SERVICE NE

VOLUME 34 AUGUS	AUGUST-SEPTEMBER, 1962		IBER 8	
	CON	TENTS		
Page		P	Page	
Corvair Engine Hot Idle	1	Oil Pump Suction Pipe— 348 and 409 Engines	2	
Bushing Installation	2	Distributor Dust Contamination		
Delcotron Pulley Installation	2	on 6-Cylinder Engines	3	
Monza Spyder Distributor	2	Corvair Accelerator Pedal	3

Fig. 1-1961-62 Corvair Carburetor Modification to Improve Hot Idle

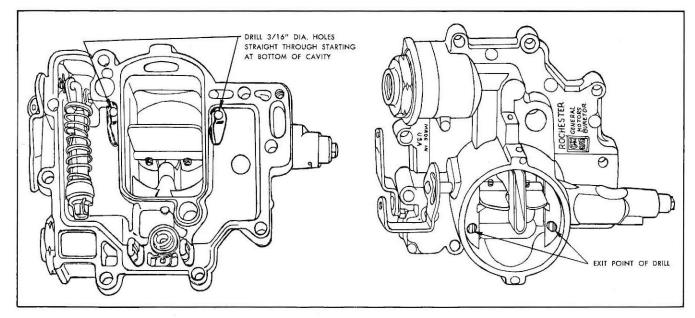
Carburetors on some 1961-62 model Corvair and Corvair "95" vehicles may require additional internal venting to improve engine idle and prevent stalling immediately after a hot start, or when

If engine stalling is evident during extremely hot weather, or under the other conditions stated above, additional internal venting may be provided as follows:

3. Locate and drill two 3/16" diameter holes in each bowl cover, as shown in Figure 1. Holes must be drilled straight through to break out inside the air horn as illustrated.
- 4. Clean out all chips, remove burrs and reassemble the carburetors.

Fig. 2-Hydra-Matic Bushing Installation

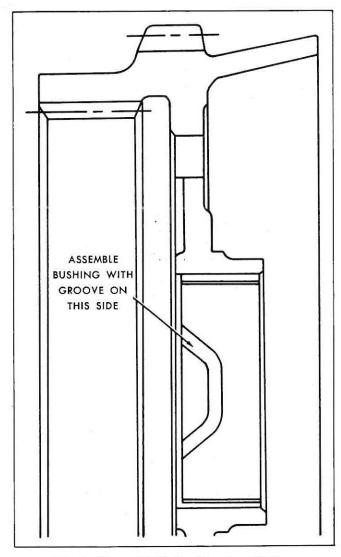
Many instances have been reported wherein a 1954-62 Chevrolet truck Hydra-Matic transmission has encountered reverse cone failure soon after transmission overhaul. In most of these cases the cone failure has proven to be the result of reverse lock-up induced by improper installation of the transmission Reverse Internal Gear Bushing.

This bushing should be installed with the oil groove facing forward in the transmission, as shown in Figure 2.

Fig. 3—Dust Shield Installed on Six Cylinder Engine Distributors

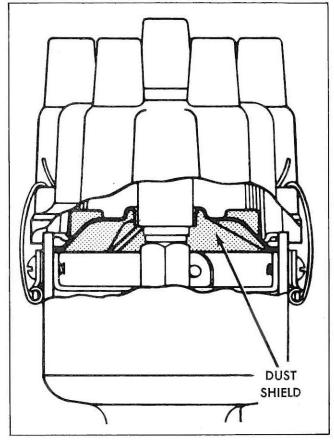
A Service only, Dust Shield, Part Number 1945388, is available to provide additional protection for all L-6 engines of the 1953 thru 1962 model

years. This shield is easily installed by removing the distributor cap and placing shield over the contact points, as shown in Figure 3.
